ORDINANCE 00-26

TO AMEND THE PRELIMINARY PLAN FOR THE GOLF COURSE COMMUNITY PLANNED UNIT DEVELOPMENT
Re: 1000 West Gordon Pike
(Richland Construction, LLC, Petitioner)

Subject: Case # PUD-14-00

BLOOMINGTON PLAN COMMISSION
PRELIMINARY REPORT
LOCATION: 1000 West Gordon Pike

Exhibit #1

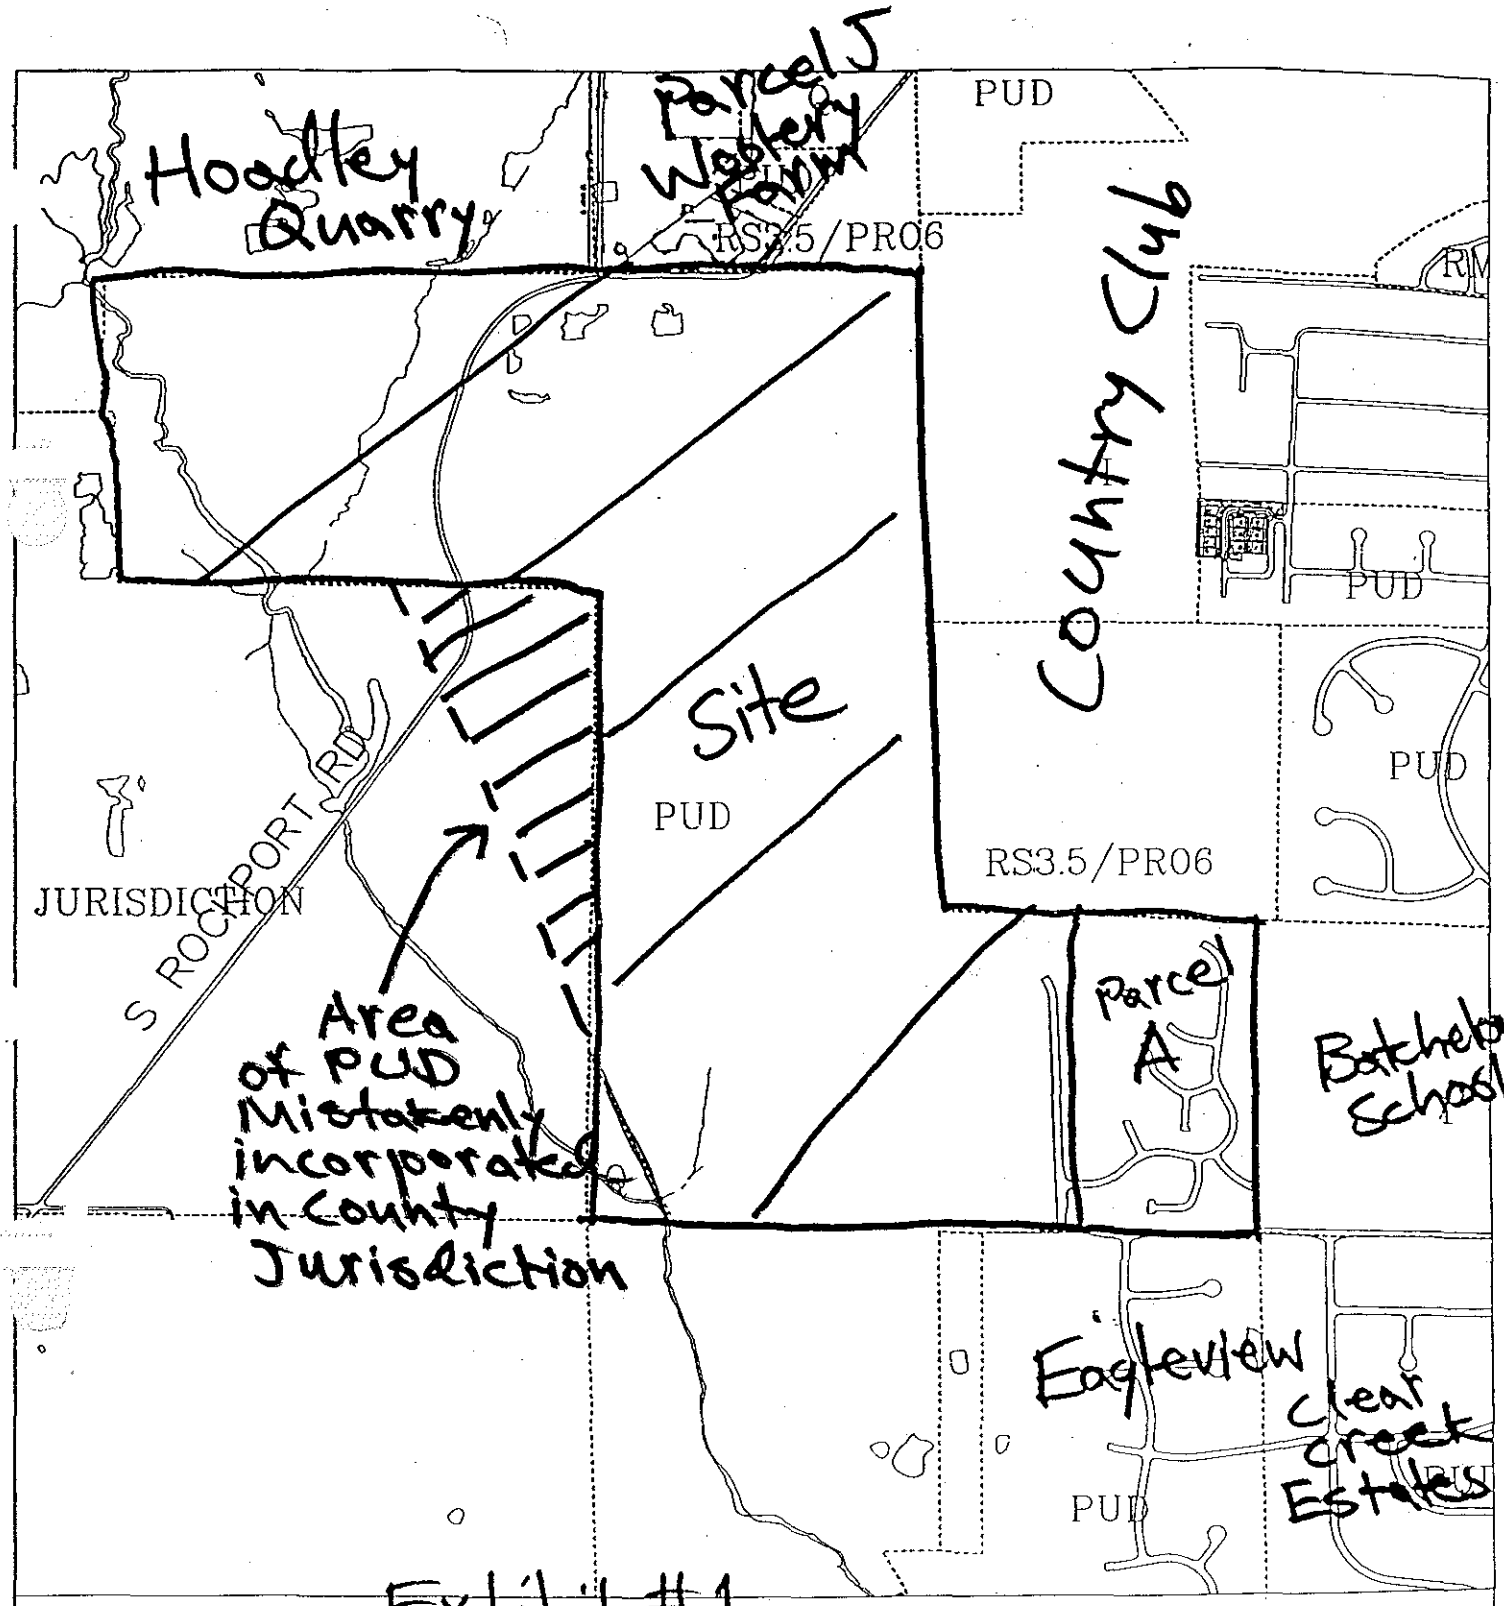
PUD LOCATION: As indicated in Exhibit #1, the PUD in question is located on the southwest side of Bloomington, at the edge of the City's planning jurisdiction. The PUD is bounded by Gordon Pike to the south, Batchelor School and Bloomington Country Club to the east, the Woolery Farm PUD and Rockport Rd. to the north, and County jurisdiction to the west. The PUD is 235 acres in size.

7) COUNTY JURISDICTION ISSUE: As is indicated on Exhibit #1, a small portion of this PUD was mistakenly mapped with the County's area of zoning jurisdiction. This mapping error occurred in 1996 due to the absence of accurate property line data. After discussing this issue with both the City and County Attorneys, the Planning staff has learned that both the County Plan Commission and County Commissioners must act to transfer the property back into the City's zoning jurisdiction. Staff has already initiated this petition with the Commissioner's office. In the interim, the City Council may still move forward on the PUD amendment. However, the petitioner will not be able to develop the encroaching acreage until the County has transferred jurisdiction to the City. Staff anticipates no difficulties with this action.

PUD-14-00
Revised Parcel Map
Exhibit #4

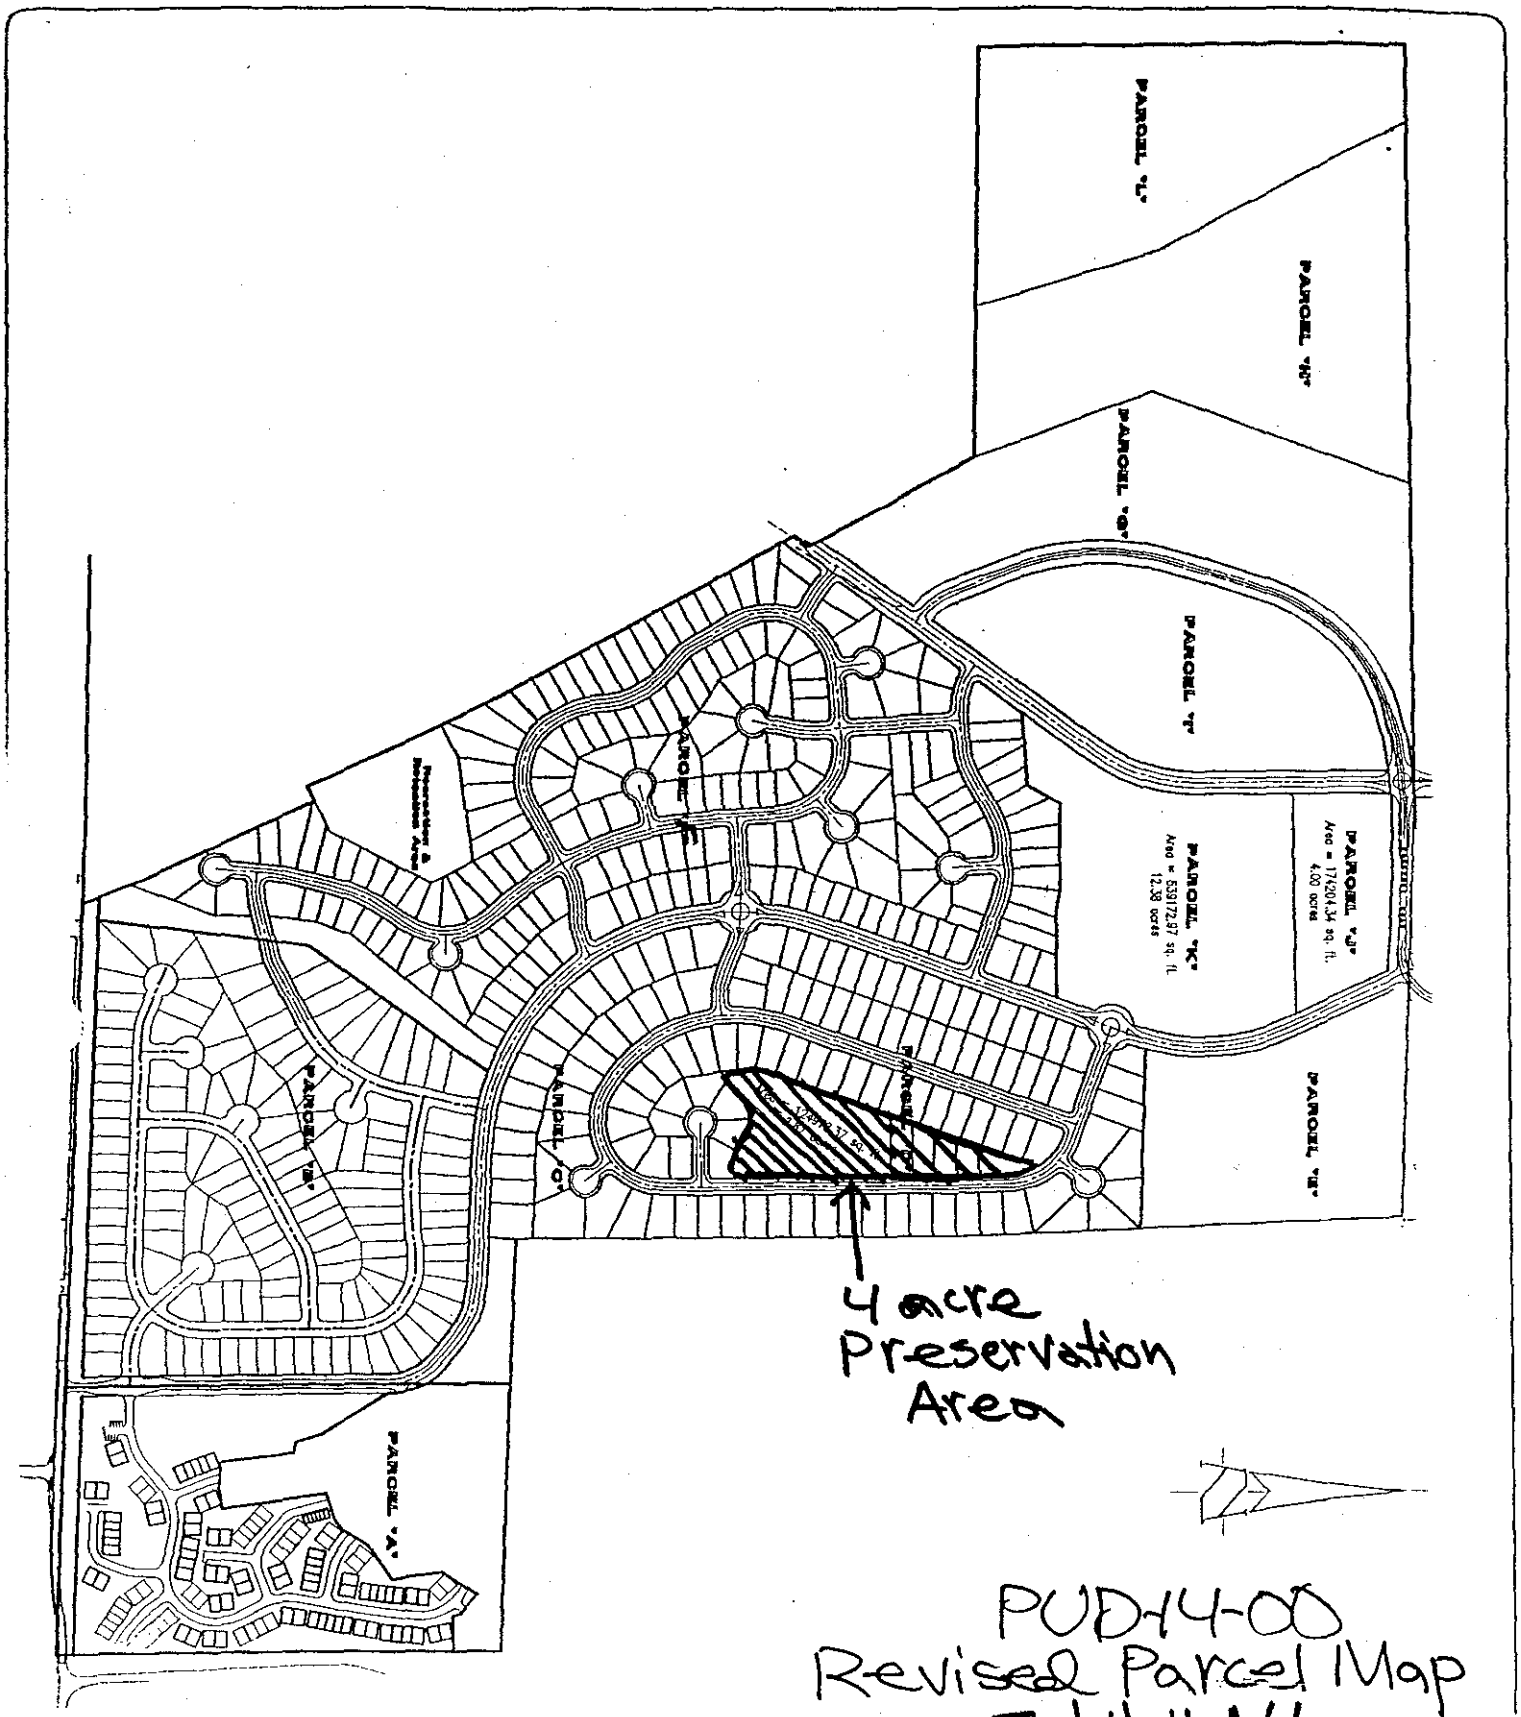
In order to mitigate the proposed increase in single family density, the petitioners are proposing the removal of 51 multifamily units located in Parcel H. This parcel is zoned for development of 270 units on 15 acres (18 units per acre). Based on the petitioner's proposal, the parcel would now be zoned for 219 units (14.6 units per acre). A re-drawn PUD parcel map is depicted in Exhibit #4.

PUD-14-00
Revised Parcel Map
Exhibit #5 - Open Space

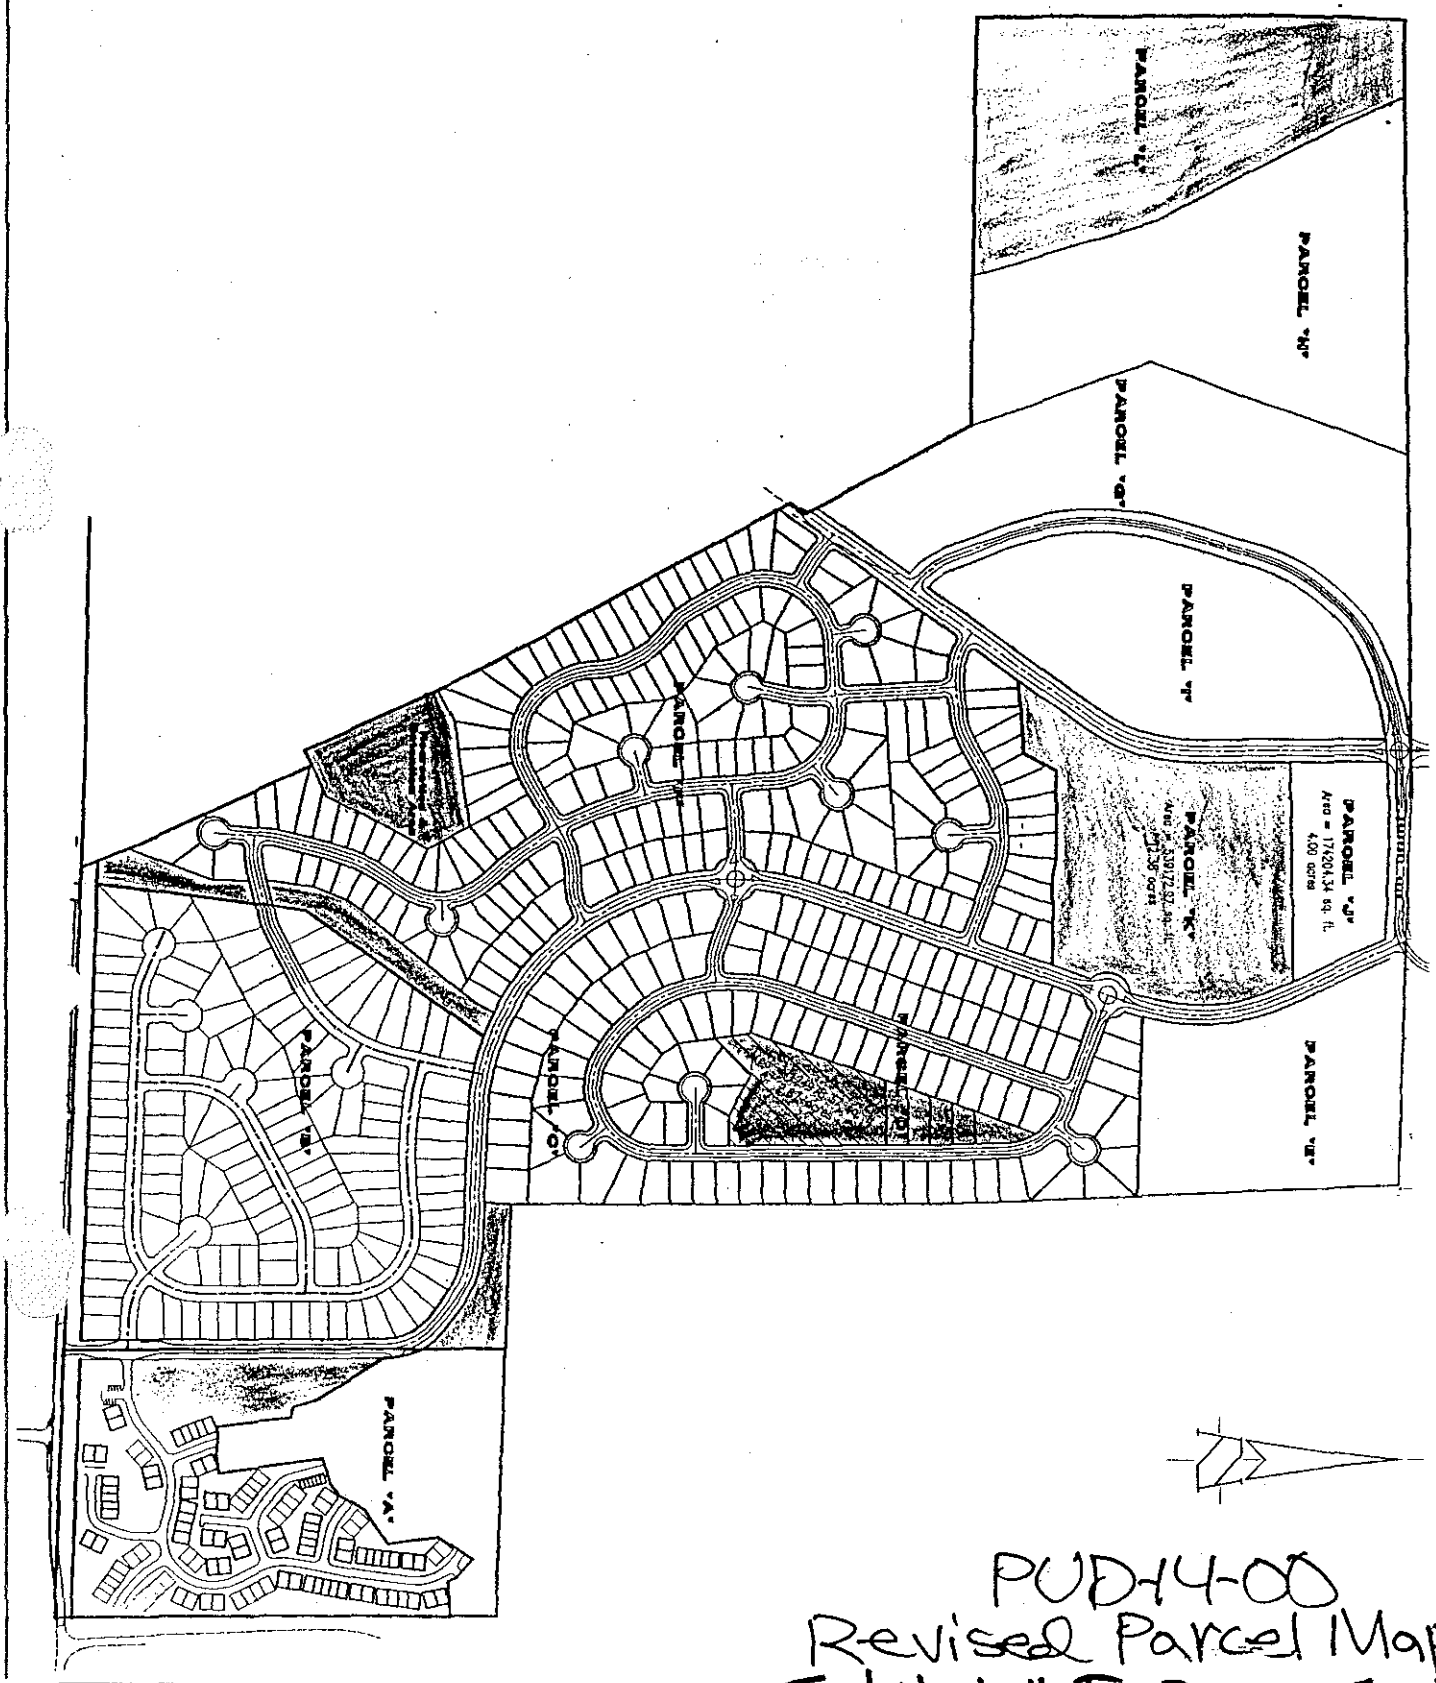
2) OPEN SPACE AND TREE PRESERVATION: As outlined in Exhibit #5, the revised PUD includes ample areas for both common open space and tree preservation. Within the development proposed for Parcel F, the petitioners have set aside a 3-4 acre area for stormwater detention. Because this area has very flat grades and will only hold water periodically, this acreage is very usable for open space activities. On Parcel D, the petitioners have committed to establishing a conservation area of over 4 acres of high quality forest. There will also be a playground area on Parcel D. In total, over 40 of the 235 acres has been set aside for common open space. This ratio is significantly greater than the common open space dedication ratios on such large PUDs as the Rogers Farm and the Canada Farm.

7. As a condition of final plat approval, the petitioners shall dedicate a tree conservancy easement of 2.87 acres in the location represented on the petitioner's preliminary plan. Additionally, staff shall review the covenants and restrictions of the final plat to insure that the City is listed as an enforcement party for violations of this conservancy easement.

PUD-14-00
Revised Parcel Map
Exhibit #6-Pathways Plan

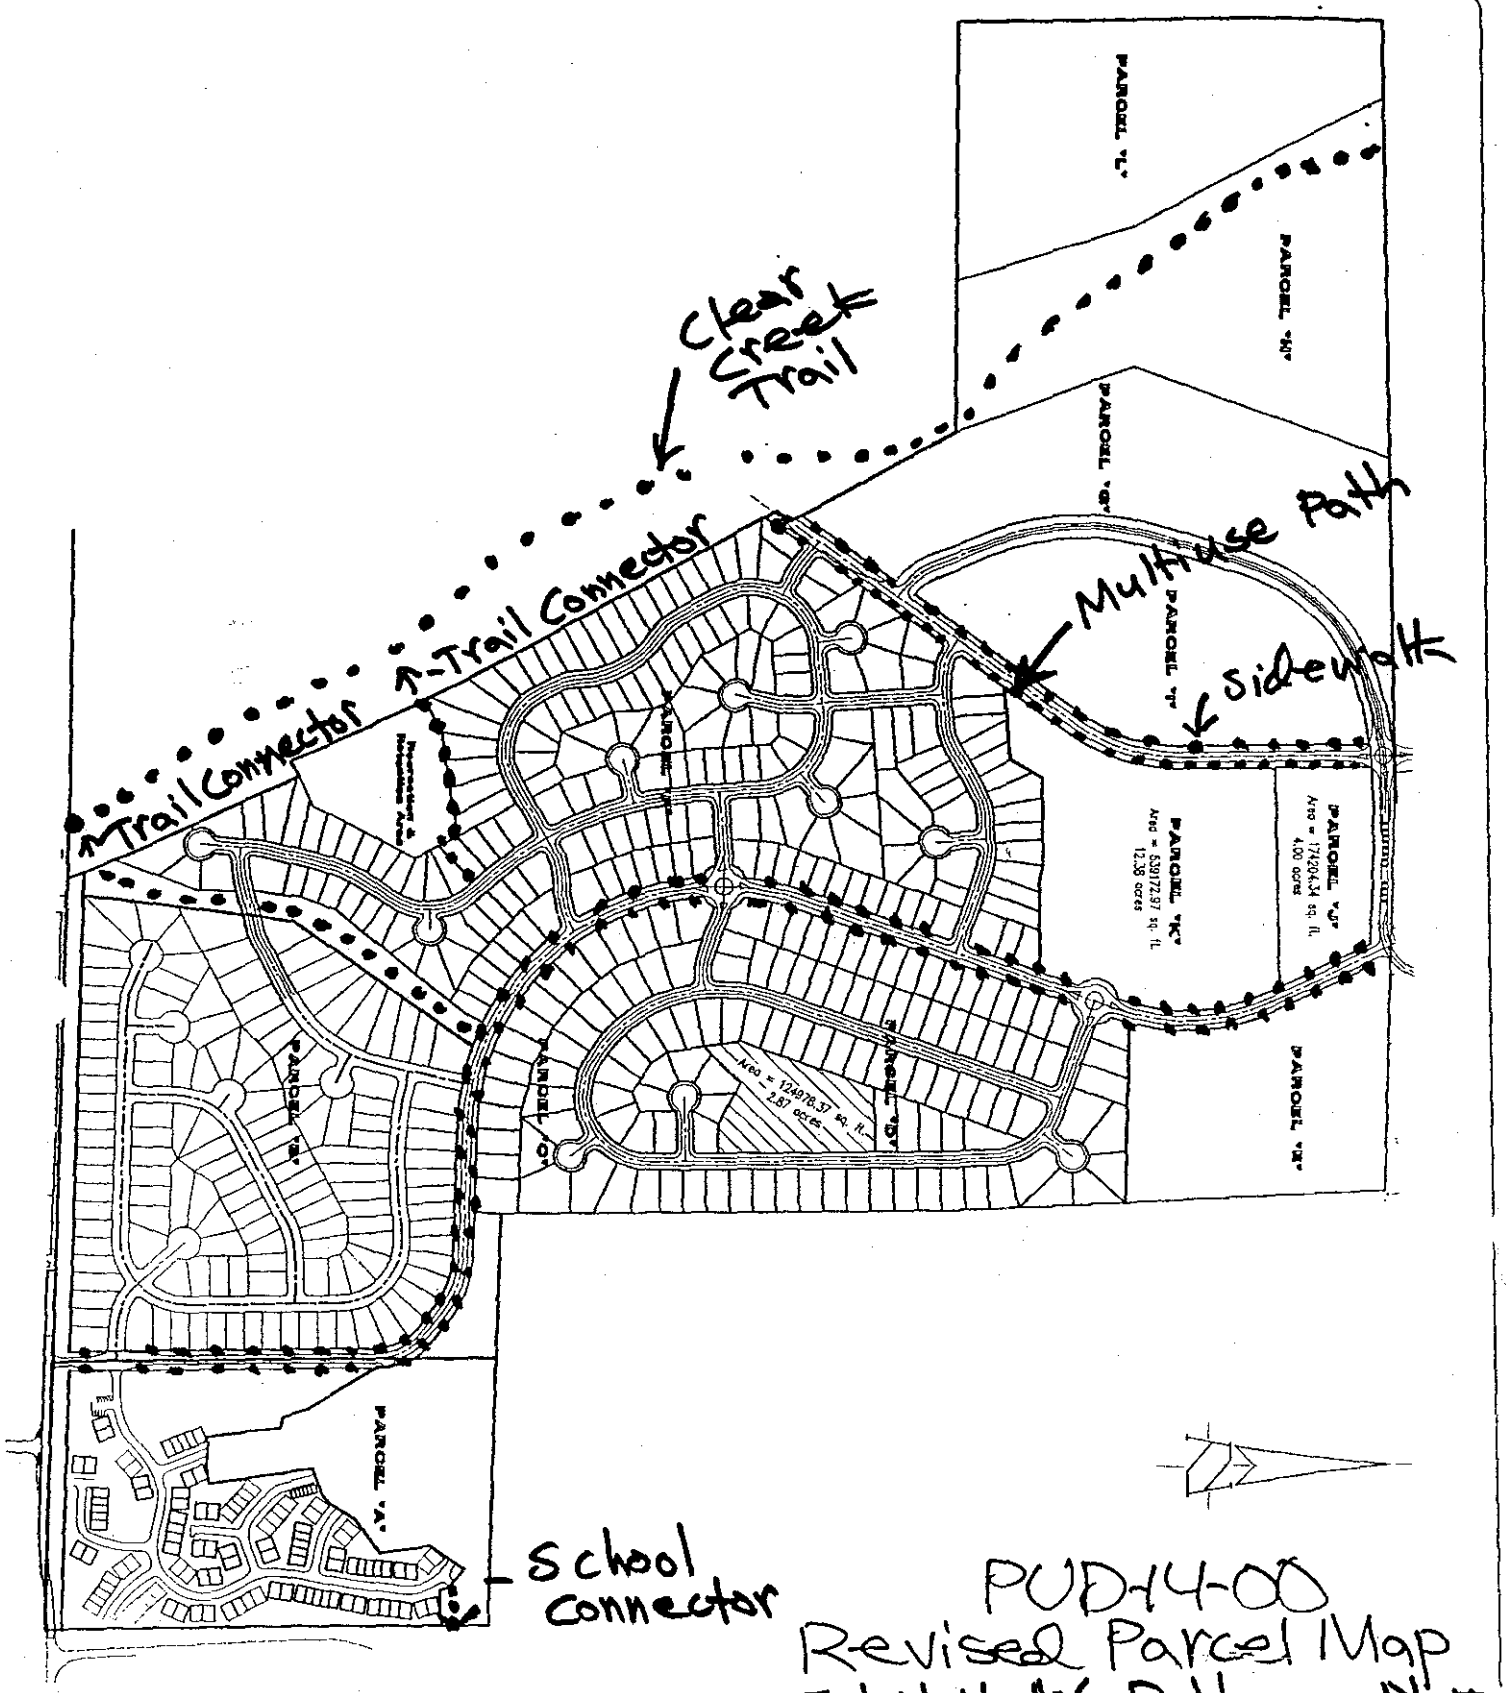
4) BICYCLE AND PEDESTRIAN ACCOMMODATIONS: As depicted in Exhibit #6, the petitioners have proposed substantial bicycle and pedestrian accommodations within the PUD. All of the internal public streets will contain sidewalks on both sides. Parcel A of the PUD also contains a sidewalk connection to Batchelor Middle School. The petitioners are extending two pathways (one between Parcels B and F, and one through Parcel F) to facilitate connections to the City's proposed Clear Creek Trail. Additionally, the proposed Adams Street extension will feature an 8-foot multiuse path on the east side of the roadway. This will connect to a similar multiuse path which will be constructed on the Woolery and Sudbury PUDs to the north. Due to a lack of Plan Commission consensus, staff has been directed to work with the Bicycle and Pedestrian Safety Commission to determine whether a multiuse path or on-street bike lanes could be constructed on Wickens Drive. The Plan Commission delegated this issue because they wanted better guidance concerning the impact of driveway cuts on these possible facilities.

3. The construction of Wickens Drive shall be reviewed as a component of grading permit review. Per the petitioner's preliminary plan, Wickens Drive shall contain 5-foot concrete sidewalks on each side as well as two traffic circles. The future Wickens Drive/Rockport Rd. intersection shall be designed to the satisfaction of both the City and County Engineers.

4. The petitioner shall extend Adams Street in conformance with the recorded "Agreement and Commitment for Public Improvements." The petitioner shall be required to install a 5-foot sidewalk on the west side of this roadway and an 8-foot sidewalk to the east. Timing for the extension of Adams Street remains the discretion of the Plan Commission in association with development of Parcels G, H, I, and J. The design of the Rockport/Adams intersection adjacent to the Woolery Farm shall be to the satisfaction of the City and County Engineers, with the petitioner urged to explore the feasibility of a roundabout design.
